Government of India - Ministry of Railways
Research Designs & Standards Organisation,
LUCKNOW - 226011

MODIFICATION SHEET No. ELRS/MS/0335, REV. '0'

Provision of time delay relay in control circuit of ac Static Converter fitted locomotive.

REF.No	PARTNo.	DESCRIPTION	DETAIL DRG.NO	NO/LOCO	MATL.	SPEC.
REF.-			SCALE-N.T.S	APPD.BY		
TIME DELAY RELAY FOR CONTROL CIRCUIT					FIRST ISSUED - Jan.2005	
RD SO. ELECT.DTE SKEL- 4691, ALT."O"					SUPERSEDED BY -

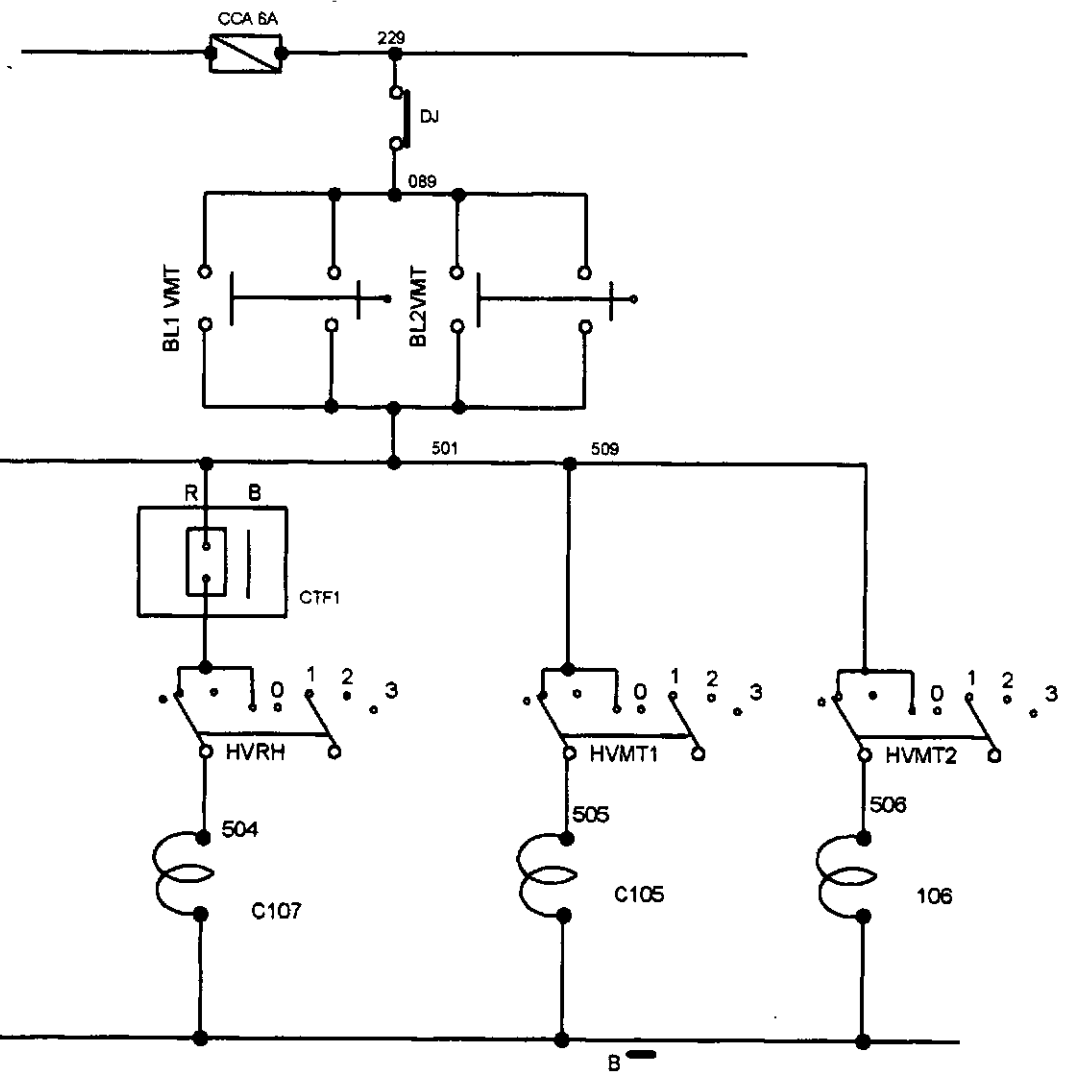
3.1 The control circuit logic is to be modified as per RDSO Sketch No. SKEL-4691.

3.2 The normally open (N/O) interlock of one timer relay (QSVM) is to be added in parallel to the normally close (N/C) interlock of BLVMT.

QSV
2 Sec.
ON DELAY
